Appendix J – Road Safety Audit Designers Response

Title: 23161 TN13 Road Safety Audit designers' response – 1st Issue

1.2 The purpose of this report is to provide a Designer's Response (DR) to the Stage 1 Road Safety Audit (RSA) carried out by 'J Bartlett Consulting Ltd' in May 2025. This Stage 1 RSA related to the access proposals associated with the two development sites.

PROJECT REF:
23161
DRAWING No:
032

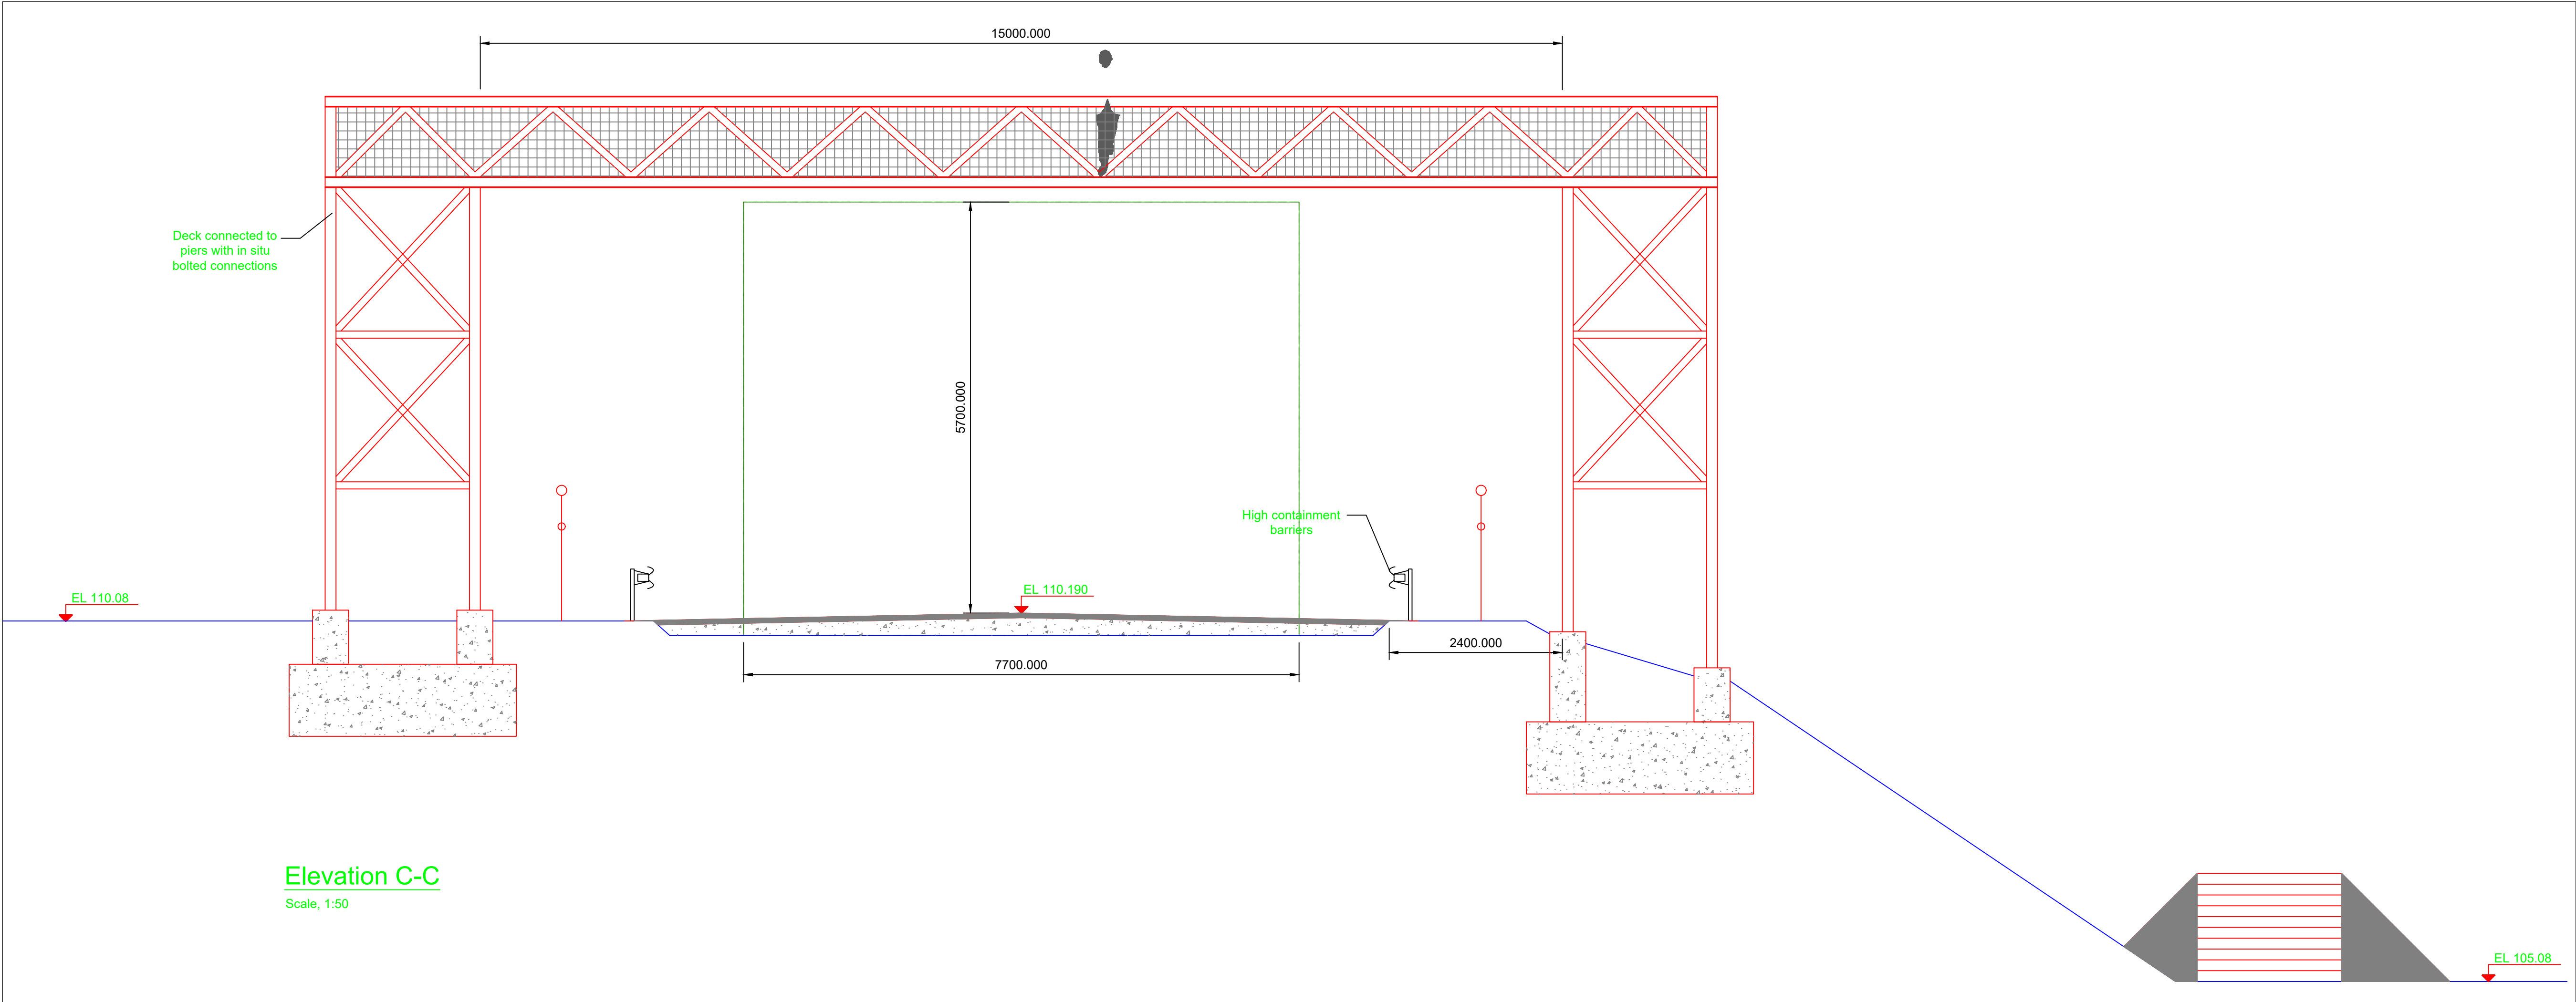
"The highway authority has requested that the introduction of a Toucan Crossing for the southbound approach to the Baldock Road roundabout junction be considered in terms of safe operation. The audit team's observations are listed below, all carrying equal significance and are in no particular order."

- *There is no indication of the likely usage of the crossing and there are concerns that where crossing are not used the 'constant' green to drivers can be overlooked if it changes to red as local drivers become over familiar with the road layout. The audit team are also aware of situations where crossings of this type revert to red and / or change to red depending on approach speed and traffic volumes, some of which are time dependant, to manage vehicle speeds on the approach to the junction and prevent the "constant" green effect. These elements, however can only be considered as the detailed design progresses;*

- *There is the potential for drivers approaching from the north in particular those unfamiliar with the area, to assume that the roundabout is signal controlled and that they have right of way leading to the potential for failure to conform type collisions; however the audit team accept that the scheme is at preliminary design and the finer detail of the provision has not been addressed.*

recognise the nature of the control should be addressed as the scheme develops and appropriate signing should be provided on all approaches to warn drivers of the controlled crossing ahead. It may also be beneficial to include count down type markers for the change in speed limit and position it further to the north to allow segregation of the speed limit change from the crossing and allow for speeds to reduce on the approach to the roundabout.
